BDCP EIR/EIS Review Document Comment Form

Document: Administrative Draft—Chapter No. 3

Comment Source: Ken Lastufka (Catrans)

Submittal Date: 7-5-13

Visual simulation from here

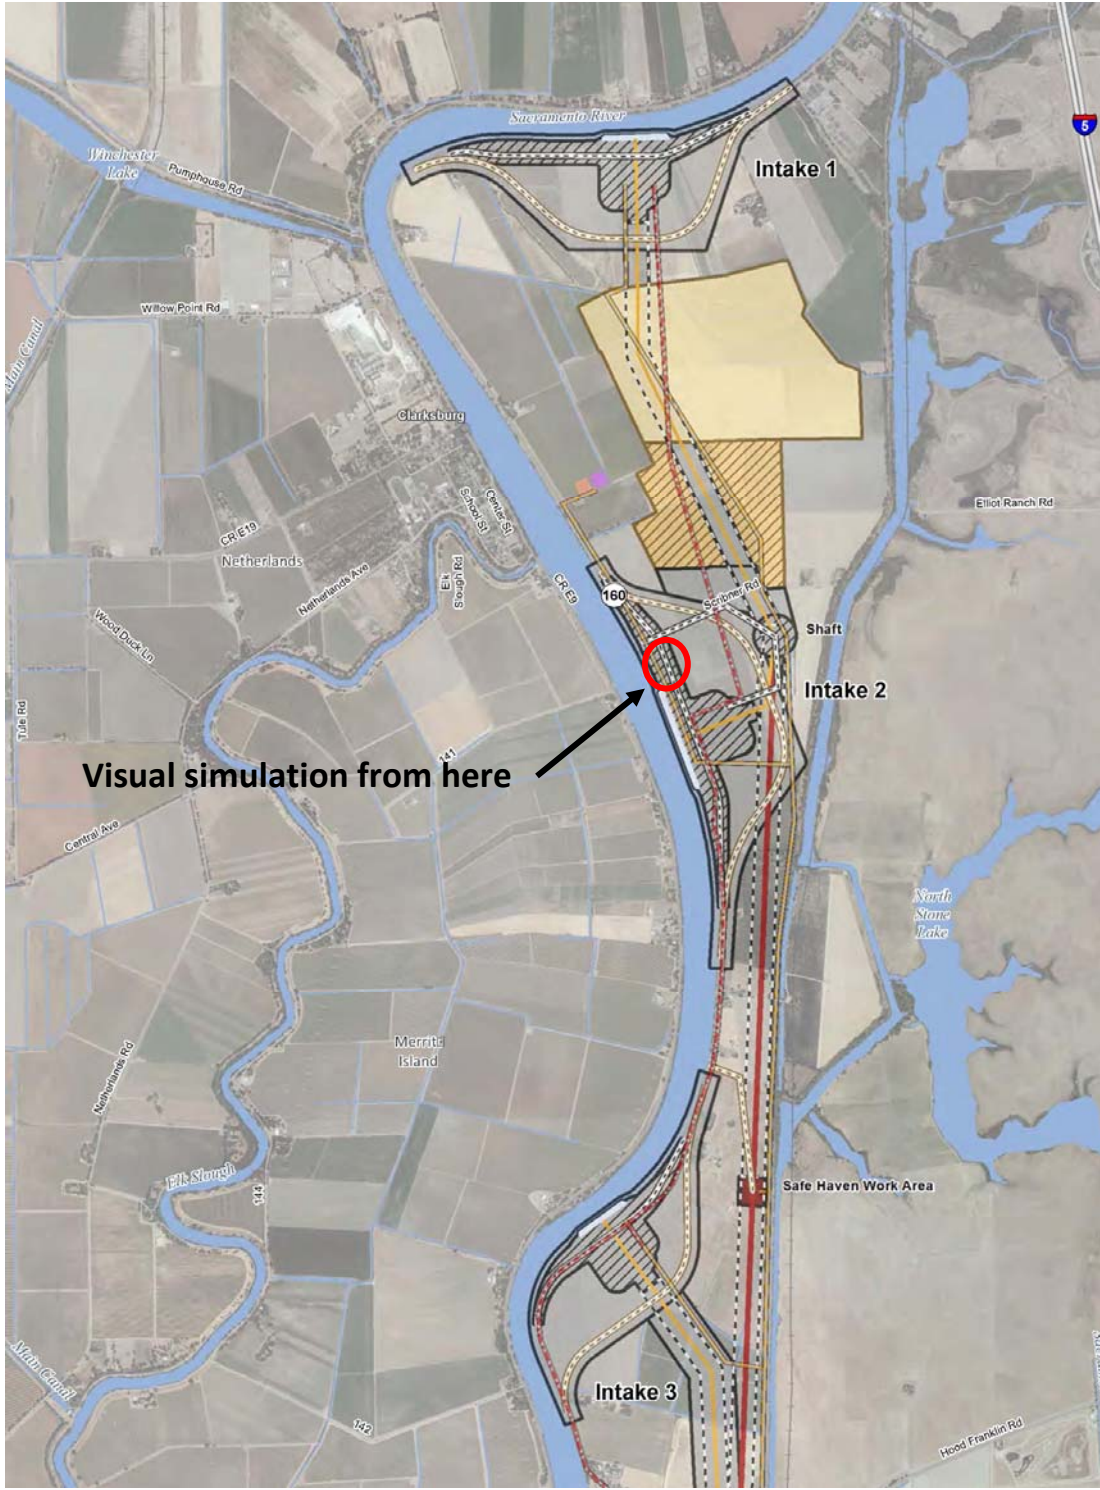
No.	Page	Line #	Comment	ICF Response
1			Figures 17-3a-d: Please provide a visual simulation that shows a re-aligned SR 160 within an intake area (see attached map).	
2				
3				
4				
5				
6				
7				
8				
9				
10				
11				
12				
13				
14				
15				
16				
17				
18				
19				
20				
21				
22				
23				
24				
25				
26				
27				
28				
29				
30				
31				
32				
33				
34				
35				
36				
37				
38				
39				
40
